# **HDC Application Addendum**

## Portsmouth NH

Market Street: Proposed (shows 41-43-45)

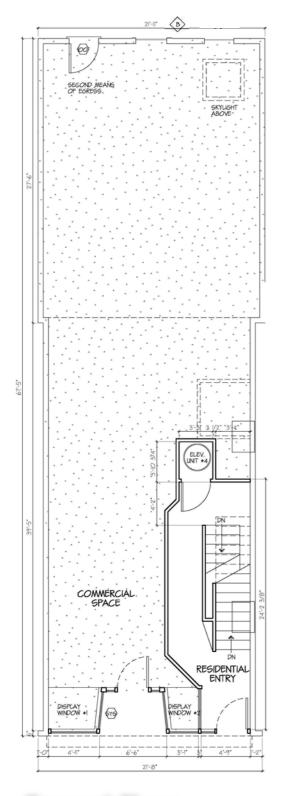
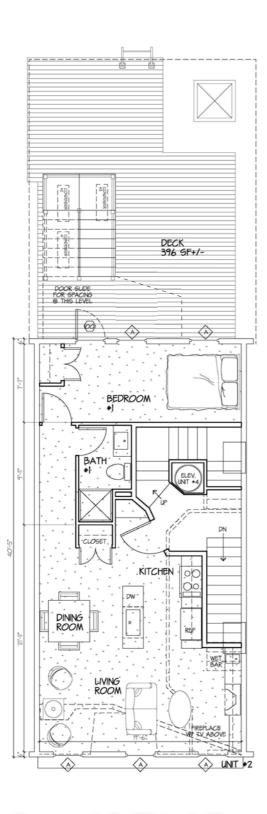
- Mimics earliest plan layout from records
- Wood Storefront System (Mahogany) & Double Pane Glass
- 2 Doors
  - 1 Commercial
  - 1 Residential

45 Market Storefront: Wood

Previously Shown: Would be softer

Dormer: Proposed

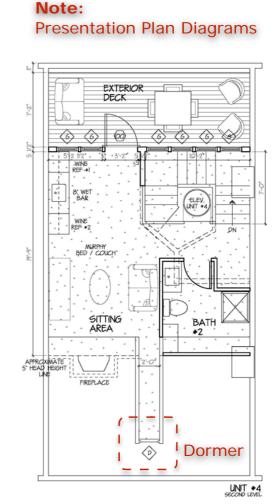
#### **HDC Application Addendum** 45 Market Street Portsmouth NH **New Deck Profile** Interior Interior Exterior **Existing Overhang Existing Overhang Proposed Overhang** Market Street **Proposed Stair Section** 1 Lite @ Dormer Note: Some elements **Glass Units** removed for clarity Maintain • FOURTH FLOOR UNT **Eave Line** Railings / Stairs: Railing Metal Railings (Powder Concept coated black) 1.5" rails / 6/1 0.5" balusters Railing · Wood treads and platforms Elevation (mahogany or similar) THRD FLOOR UNIT 1 Lite Simple profiles @ Doors 6/1 Wood slats @ HVAC area 1 1/2" DIAMETER PIPE RAILING ALL MATERIAL POWDER COATED BLACK 1 1/2" DIAMETER PIPE RAILING 6/1 2" METAL DECKING 4" X 4" METAL POSTS ALL MATERIAL POWDER C: Railing Concept HVAC CONDENSER YARD UNDER STARS WITH VERTICAL BOARDS TO CREATE SCREENING AND RECOMMENDED AR FLOW FOR (4) UNITS Filled In Existing 1 Lite **HVAC** area **HVAC** 9-18-2020 @ Door ROOF DECK LEVEL **Proposed Stair & Railing Concepts Existing Rear Elevation Proposed Rear Elevation** architects 3 interiors

## Existing Rear Elevation Photo #1

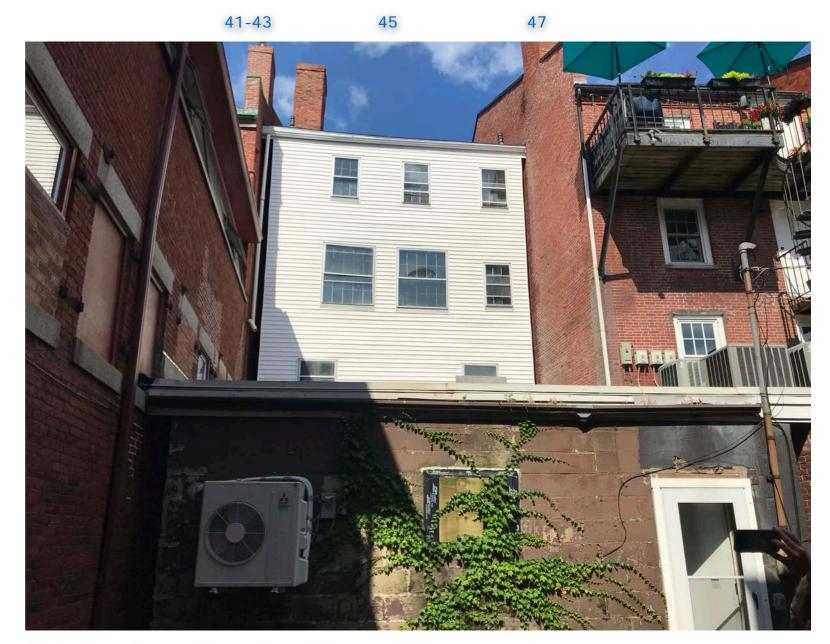
- Work at gutters and HVAC condensers at 41-43 will help the connection between 45
- This project to coordinate work with 47 owner for new stair work
- New stairs and HVAC area to be located on roof of 45 and approximately 9" away from 47 brick face
